Canby OR 99E Corridor and Gateway Plan Community Meeting #2 – Meeting Summary

Canby OR 99E Corridor and Gateway Design Plan

**Canby OR 99E Corridor and Gateway Plan
Gateway Plan Advisory Committee Meeting 3
January 31, 2012 (2:30-4:00 p.m.)
Hope Village Community Center (Canby, Oregon)**

Wide Sidewalks for Pedestrians/Bikes

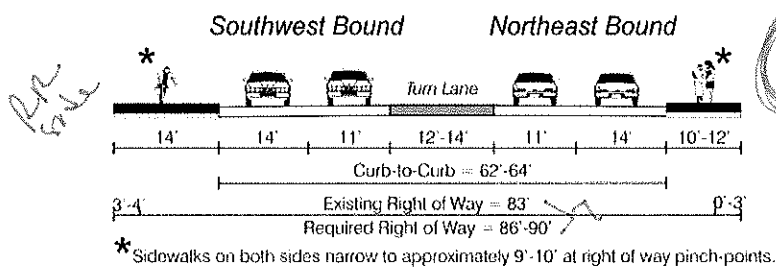
Best for bikes & trucks

Buffered Bike Lanes

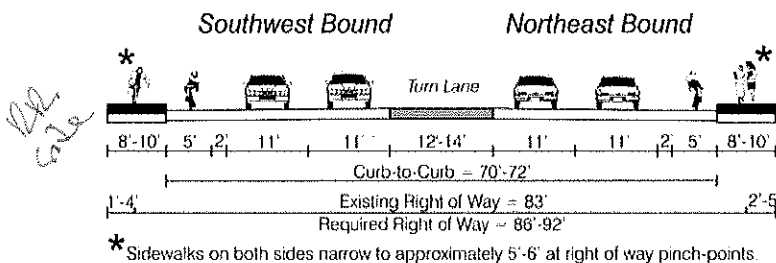
We'll never get the right-of-way. Dikes don't like heavy on 99E anyway

Standard Special Transportation Area (STA)

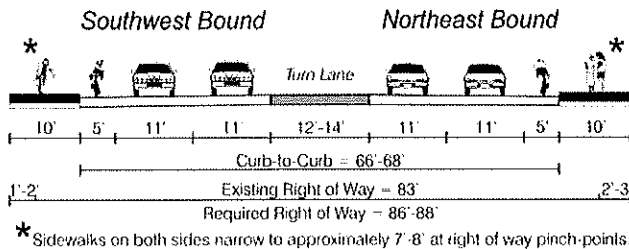
no bike lanes
bring them through downtown
on 1st Ave

Standard Special Transportation Area (STA)

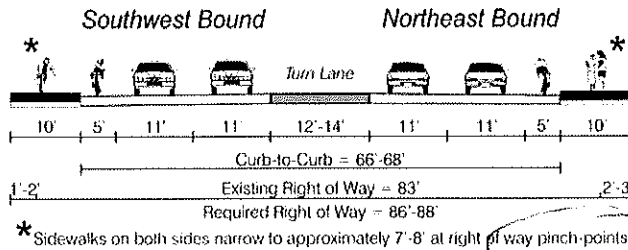
Comments: - No bike lanes on 99E.

Wide Sidewalks for Pedestrians/Bikes

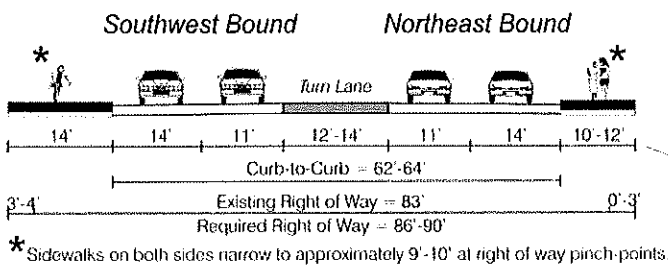
Comments: - No bike lanes on 99E
 - 10'-12' on both sides

Buffered Bike Lanes

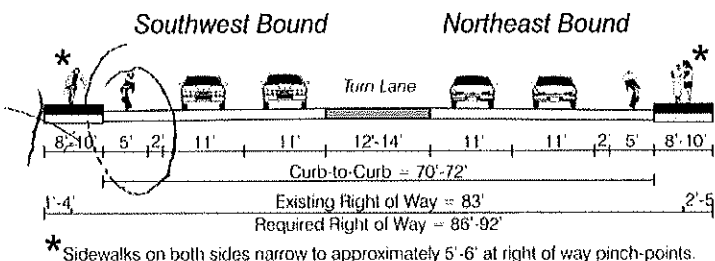
Comments: - No bike lanes on 99E

Wide Sidewalks for Pedestrians/Bikes

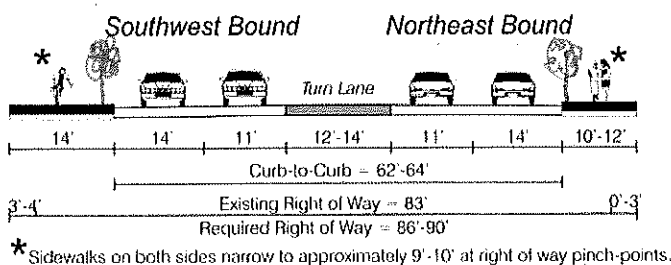
Bikes rarely use 99 thru Canby
re-route them off to 1st Ave
Add trees to separate sidewalk users
from roadway

Standard Special Transportation Area (STA)

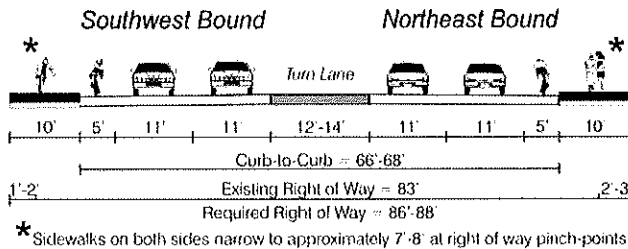
NO Bike lane
10-12 Sidewalks
